RECALL CAMPAIGN 5333

**Models FIAT Linea / Albea / 500 / G.Punto / Idea with 1.2 / 1.4 8V petrol engines and Fiat G. Punto 1.4 8V Natural Power.
- petrol manifold**

**Linea-Albea-500-GPunto-Idea models with 1.2/1.4 8V EVO and 1.4 EVO CNG engines
- fuel manifold (VERIFICATION PROCEDURE)**

**Fiat Linea, Albea, 500, GPunto, Idea models with 1.2/1.4 8V EVO and 1.4 EVO CNG engines
- petrol manifold**

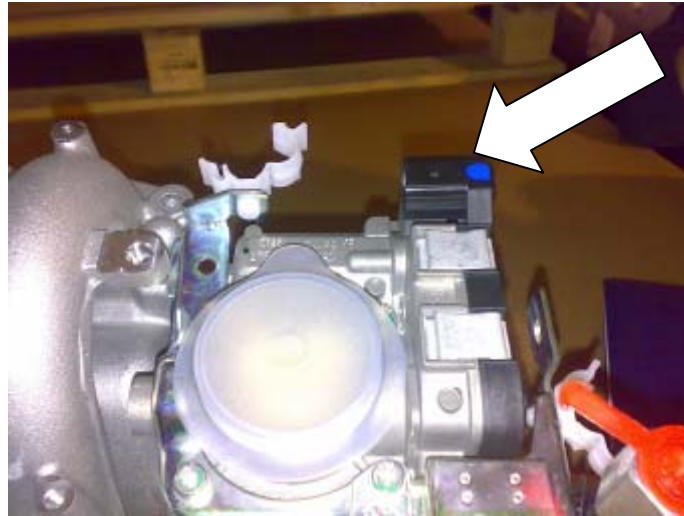
Check the press number on the injector manifold fastening tab on the side where the fuel pipe quick-coupling is attached.

If the number is "2", the vehicle is compliant and may be released.

If the number is "1", the vehicle is not compliant must be blocked to await instructions.

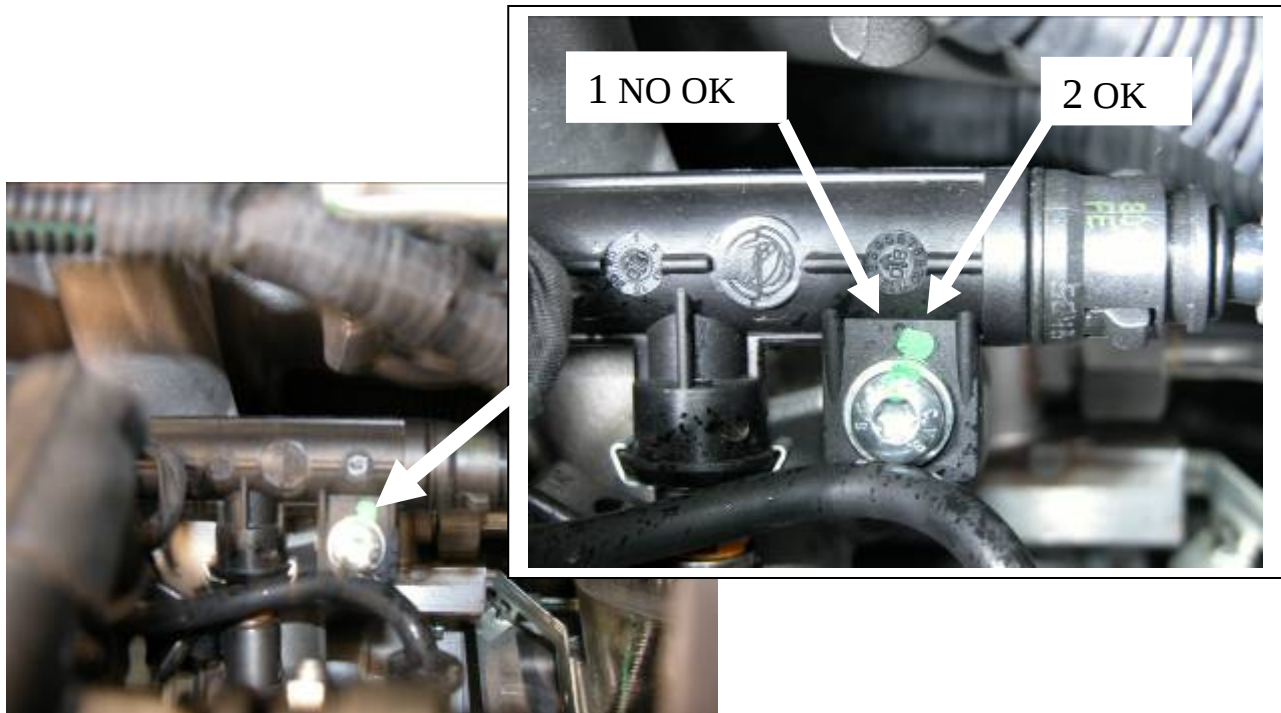
Check for the presence of a BLUE, YELLOW or GREEN stamp on the throttle body connector.

- If present the vehicle is compliant and may be released.
 - If this is not present, the vehicle is not compliant. In this case, proceed as follows:
- Remove the air filter casing assembly.

Check the press number on the injector manifold fastening tab on the side where the fuel pipe quick-coupling is attached.

If the number is “2”, the vehicle is compliant and may be released.

If the number is “1”, the vehicle is not compliant must be blocked to await instructions.

IDENTIFICATION OF OPERATION:

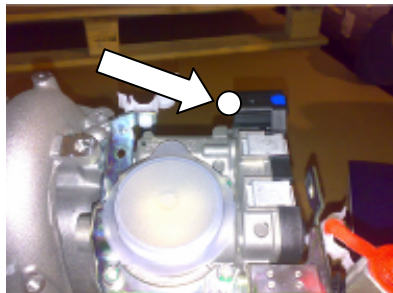
White paint spot on the throttle body connector near the blue , yellow or green mark, if present.

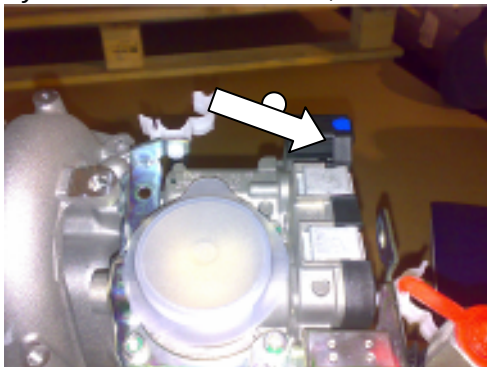
Repair procedure for blocked cars with replacement of injector manifold.

Note: the air filter box has already been removed during the check cycle.

- Replace the injector manifold with **part. 55195806** as described in operation 1056 B 60.
- Fit the parts by reversing the removal instructions.
